STAFF RECOMMENDATION
3828 Whitland Avenue
May 15, 2013

Application: Demolition - Outbuilding; New Construction – Outbuilding; Reduce Setbacks

District: Whitland Avenue Neighborhood Conservation Zoning Overlay

3 ROOF PLAN
SCALE @ 1/4" = 1'-0"

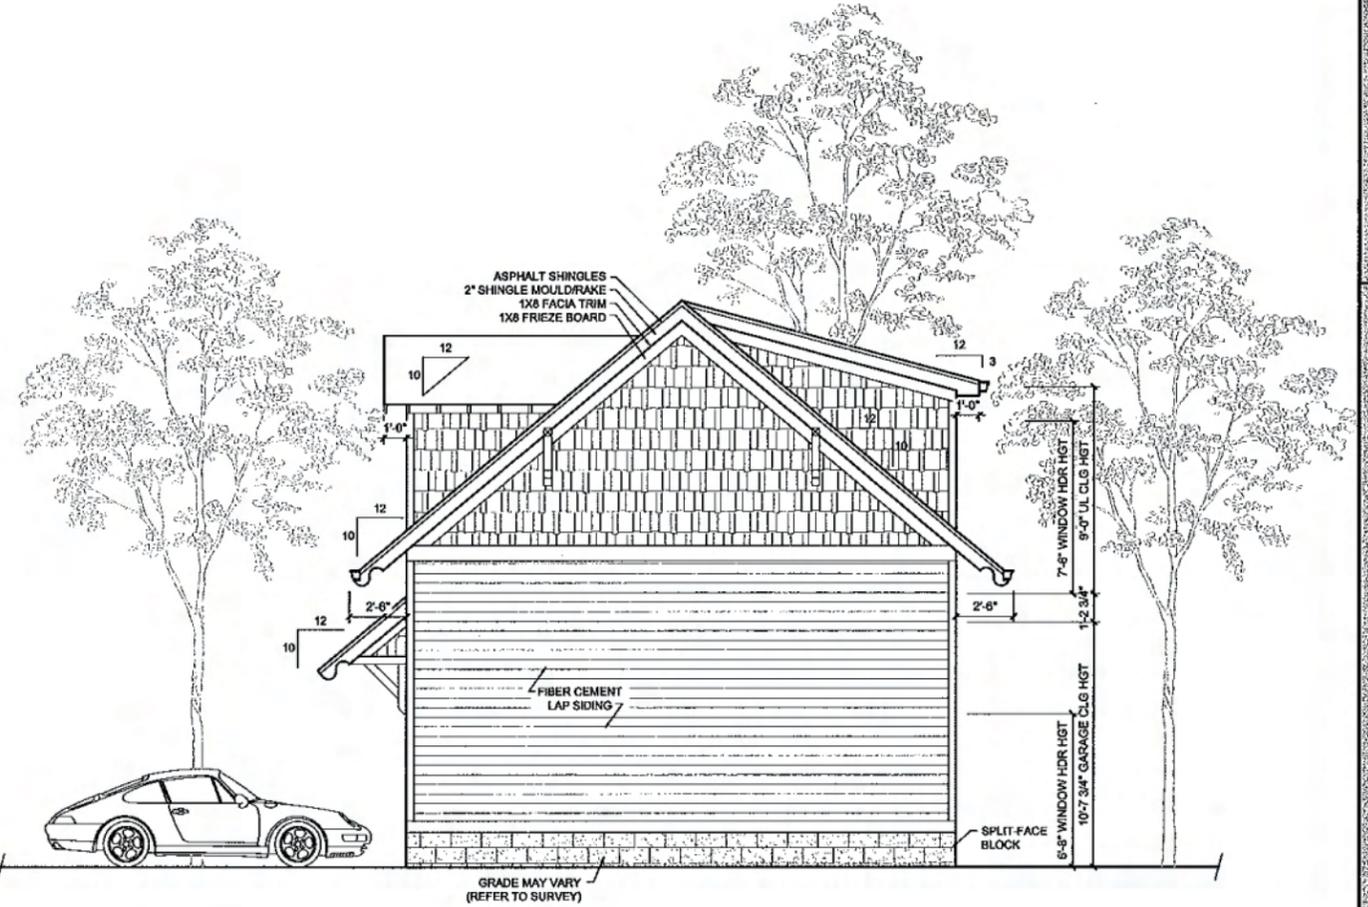
The primary roof of the new building will be a side-oriented gable with a 10:12 pitch, matching the pitch of the roof of the house. Three gabled dormers on the front slope will have the same pitch, and a rear shed dormer will have a 3:12 pitch. These roofs are compatible with those of the house and will meet guideline II.B.1.e.

2 RIGHT ELEVATION
SCALE @ 1/4" = 1'-0"

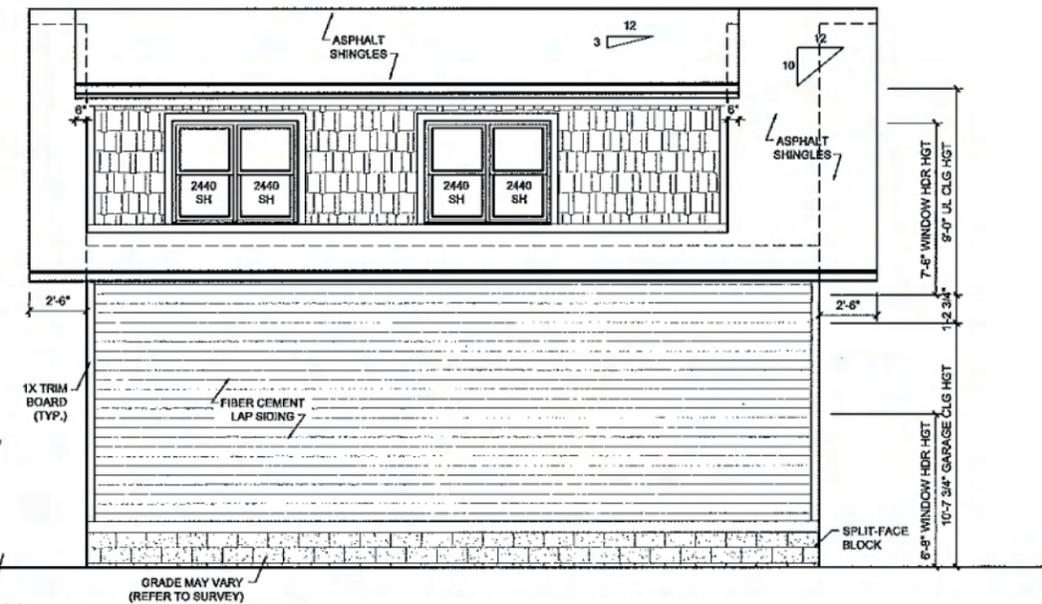
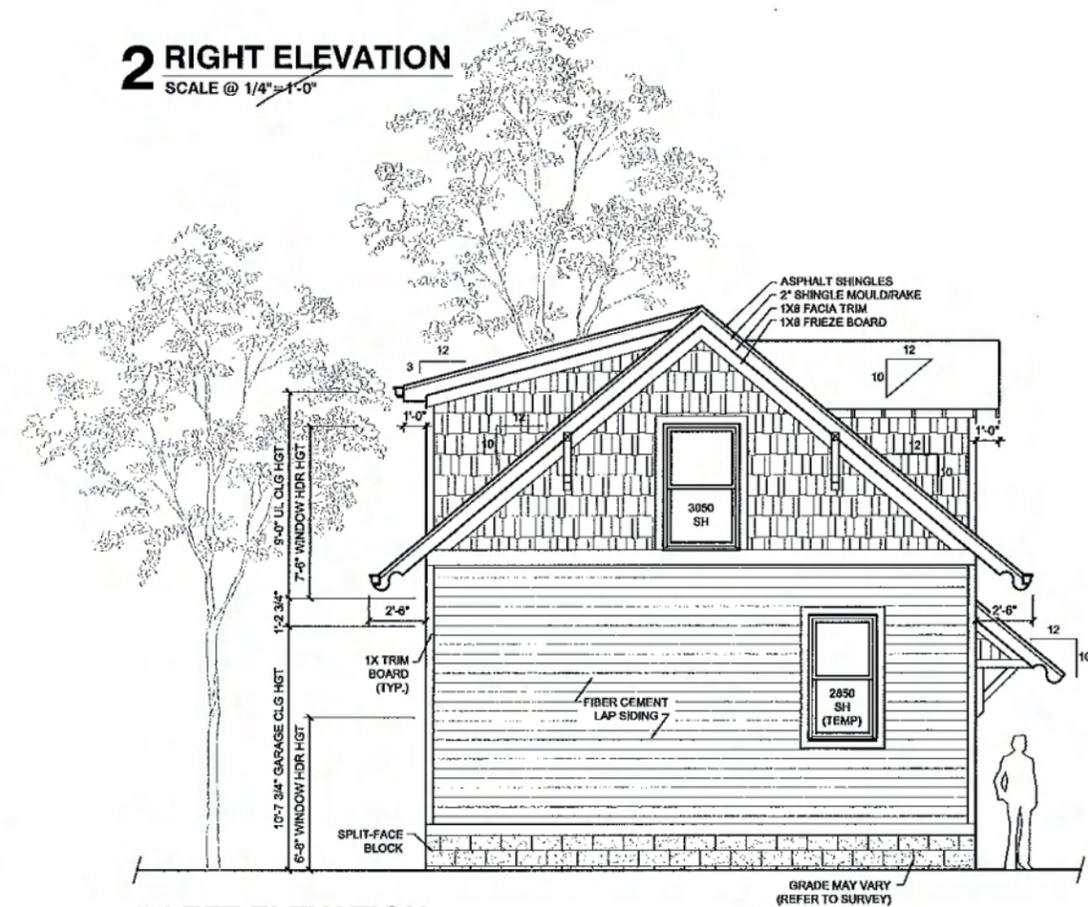
The new accessory building will have a side-gabled roof with a ridge height of twenty-four feet (24') tall at the peak, with an eave height of twelve feet (12'). The building will have two courses of foundation exposed above grade and a pent-roof on the front with an eave at eight feet (8') above grade. These features, combined, will help to reduce the perceived height of the building as viewed from the right of way.

The exterior materials of the new accessory building will include a split-faced block foundation, cement-fiber clapboard siding, and a composite shingle roof. More information is needed about the materials of the windows and doors, the shake siding in the gable fields, and the color of the roof. With the unknown materials to be approved administratively, staff finds that the other materials are compatible with those of the house and surrounding buildings, and meet guideline II.B.1.d.

The garage will have a pair of front-facing vehicle doors, a front-facing pedestrian door. Because the property does not have an alley at the rear, this orientation and the placement of the doors is appropriate. The location and proportion of windows is also appropriate for outbuildings. Staff finds the new building will meet guidelines II.B.1.f. and II.B.1.g.

Recommendation: Staff recommends approval of the proposed new outbuilding with reduced setbacks, with a condition that the unknown materials are approved administratively, finding that the structure will meet the applicable design guidelines for the Whitland Avenue Neighborhood Conservation Zoning Overlay.
